**Awareness of the Proximity of Vulnerable Road Users:
UN Regulation No. 46 (Devices for indirect vision)**

Proposal for Supplement 1 to the 05 Series of Amendments to UN Regulation No. 46 (Devices for indirect vision)

Submitted by the expert from the International Organization of Motor Vehicle Manufacturers *

Figure 9
Figure 9.1
 Class VI field of vision for side-steered vehicle

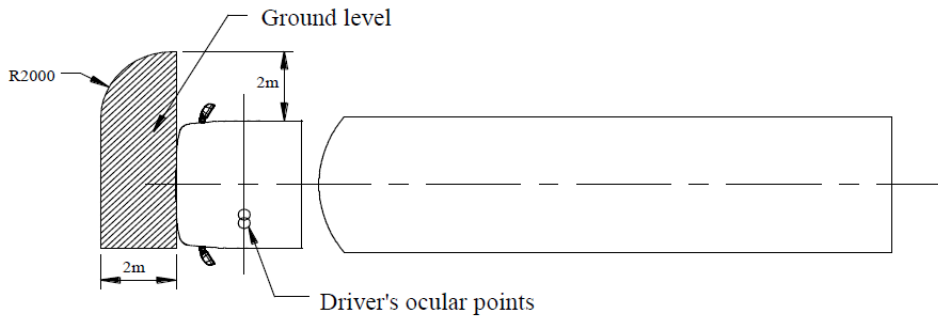
"15.2.4.6.1. The field of vision shall be such that the driver can see at least a flat horizontal portion of the road, which is **for side-steered vehicles** bounded by:

- (a) A transverse vertical plane through the outermost point of the front of the vehicle;
- (b) A transverse vertical plane 2,000 mm in front of the plane defined in (a);
- (c) A longitudinal vertical plane parallel to the longitudinal vertical median plane going through the outermost side of the vehicle at the driver's side; ~~and~~
- (d) A longitudinal vertical plane parallel to the longitudinal vertical median plane 2,000 mm outside the outermost side of the vehicle opposite to the driver's side.; **and**
- (e) ~~The~~ **the** front of this field of vision opposite to the driver's side may be rounded off with a radius of 2,000 mm (see Figure ~~9~~ **9.1**).

Figure 9.1., amend to read:

Figure 9.2
 Class VI field of vision for centre-steered vehicle

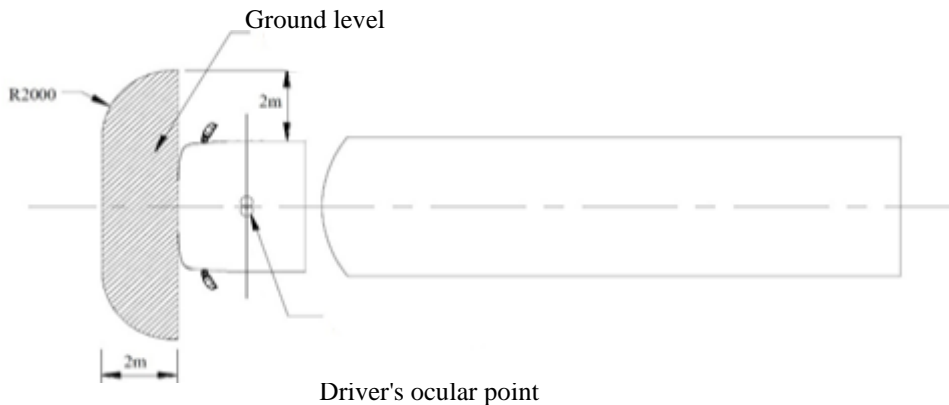
The field of vision shall be such that the driver can see at least a flat horizontal portion of the road, which is for centre-steered vehicles bounded by:

- (f) **A transverse vertical plane through the outermost point of the front of the vehicle;**
- (g) **A transverse vertical plane 2,000 mm in front of the plane defined in (a);**
- (h) **A longitudinal vertical plane parallel to the longitudinal vertical median plane 2,000 mm outside the outermost side of both sides of the vehicle; and**
- (i) **The front of this field of vision on both sides may be rounded off with a radius of 2,000 mm (see Figure 9.2).**

Insert a new figure 9.2., to read:
